Amendments to the Drawings

REMARKS

FIG. 4

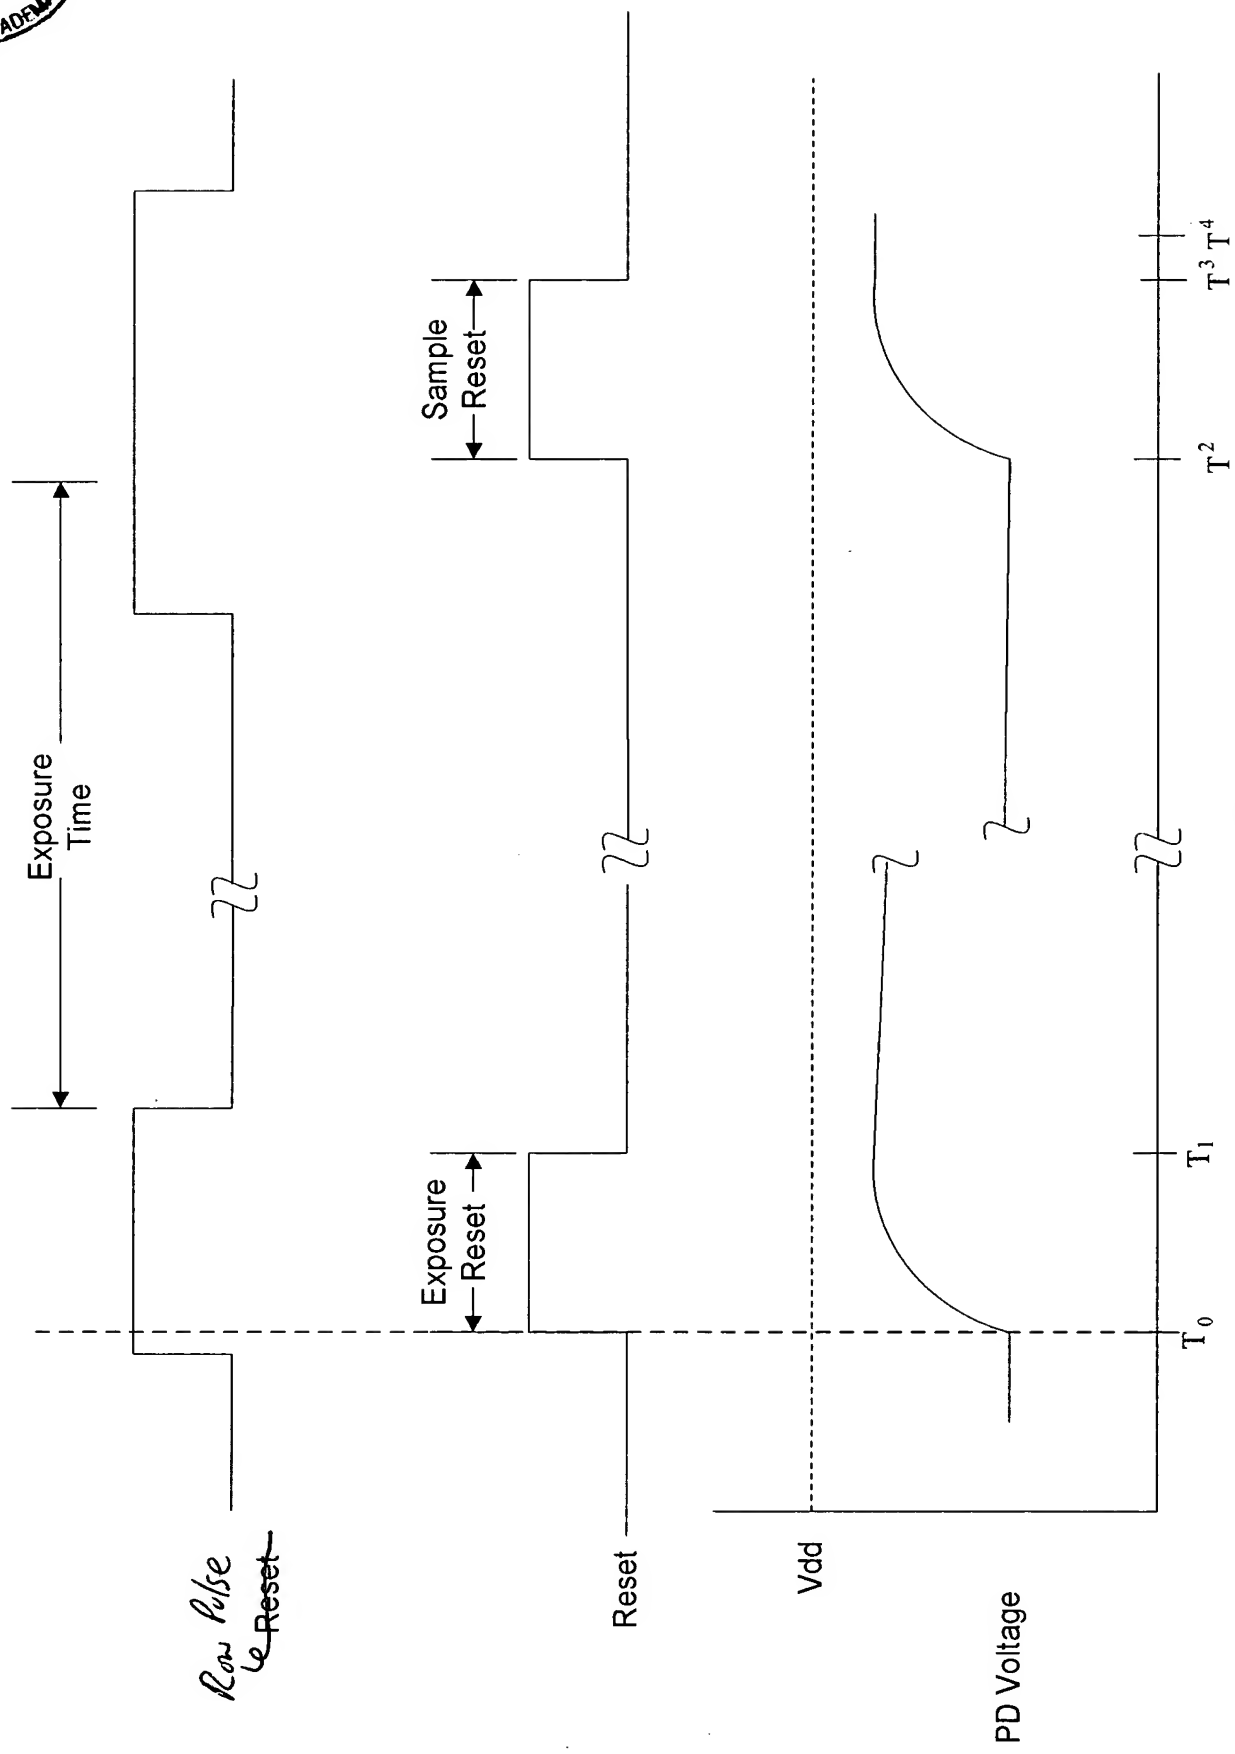
The attached sheet of drawing includes changes to Fig. 4. In Fig. 4, a duplicative reference text "Reset" has been replaced with a reference text of "Row Pulse."

Applicant has amended Fig. 4 to replace a duplicative reference text of "Reset" with a reference text of "Row Pulse." Support for this amendment can be readily found in p. 13, line 22 to p. 14, line 2.
